SUBJECT: PURDUE UNIVERSITY - REQUEST FOR ADDITIONAL INFORMATION REGARDING
THE PURDUE UNIVERSITY REACTOR LICENSE RENEWAL (TAC NO. ME 1594),
RESPONSES TO RAIs (ML103400115 and ML103400250)

REQUESTED ADDITIONAL INFORMATION IN RESPONSE TO RAIs

REGARDING THE PURDUE UNIVERSITY REACTOR LICENSE RENEWAL (TAC NO. ME 1594)

Figure 1: Weekly make-up water usage for PUR-1.

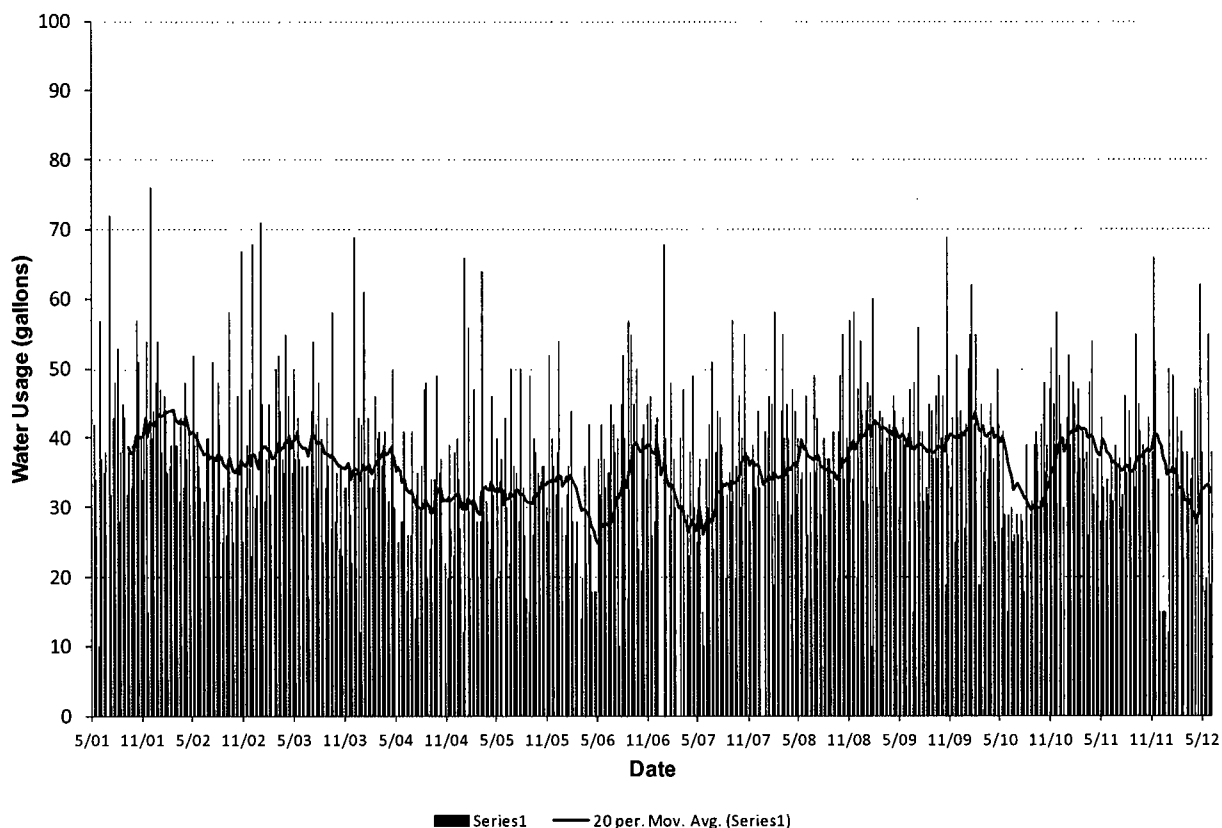
52. SAR Section 5.5 describes automatic pool water level control. Please describe how you would determine if the amount of make-up water to the reactor pool was excessive and indicative of a pool leak.

- Please provide an estimate of the minimum detectable amount of leakage and an estimate of how long such a leak could exist before detection; any trends associated with the required make up water, and the physical means with which PUR-1 can detect small releases from the pool directly to the environment.**

The automatic pool water level control is only activated when needed to replace evaporated coolant inventory, and the automation is solely to prevent overfill of the pool. Operations staff activate the system, and track the amount of water used each time in a log book. Data exists for facility water usage back to

about 1974. In looking at the last 15 years, the average weekly water usage has been 36.8 ± 12 gallons. The data are presented in Figure 1. Weekly usage that exceeds the average value plus three standard deviations could indicate a leak.

Pool level is monitored by comparison of the pool level to a ruler at the top of the pool, and is observed at least once a week by reactor staff members. Make-up water usage is tracked in a log book on the console. In looking at the last 15 years, the average weekly water usage has been 36.8 ± 12 gallons. The data are presented in Figure 1. Weekly usage that exceeds the average value plus three standard deviations could indicate a leak.
